# Staff Report

## Site Plan Review

SP-01-20

## 3551 David Avenue NE

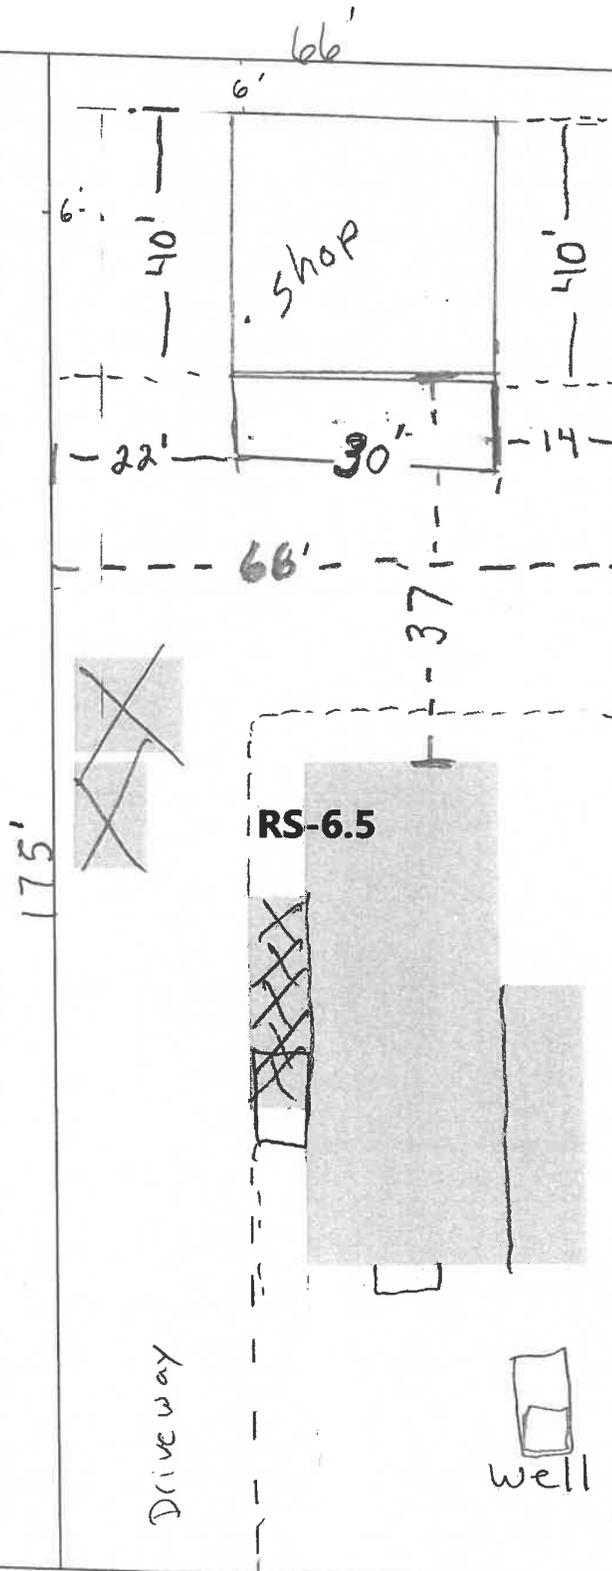
- 5.8 Per ADC 3.230, Table 2, detached accessory structures with walls greater than eight feet require an interior setback of five feet. The applicant's site plan indicates the accessory structure is at least six feet from the interior lot line (Attachment B.1). However, given the margin of error, staff are unable to utilize aerial images to confirm whether the structure meets the interior setback.

- 5.9 The owners of the abutting property to the north provided written comments (Attachment C). The property owners stated that they believe the survey markers have been moved and questioned whether the structure meets the required interior setback. Building setbacks are typically assessed at time of the foundation inspection. This ensures the building is not constructed within a required setback before it is fully constructed. However, the applicant constructed the structure without land use review or building permits, negating the opportunity for City officials to confirm the setback prior to construction. A condition of approval will require the applicant to submit a survey that demonstrates the structure meets the required setbacks. The survey shall bear the insignia of a professional land surveyor licensed in the State of Oregon.

- Condition 3 Prior to issuance of a building permit, the applicant shall provide a survey that demonstrates the structure meets the required interior setback. The survey shall bear the insignia of a professional land surveyor licensed in the State of Oregon.
- Condition 4 Development shall occur consistent with the plans and narrative submitted by the applicant, or as modified by conditions of approval and shall comply with all applicable state, federal, and local laws.
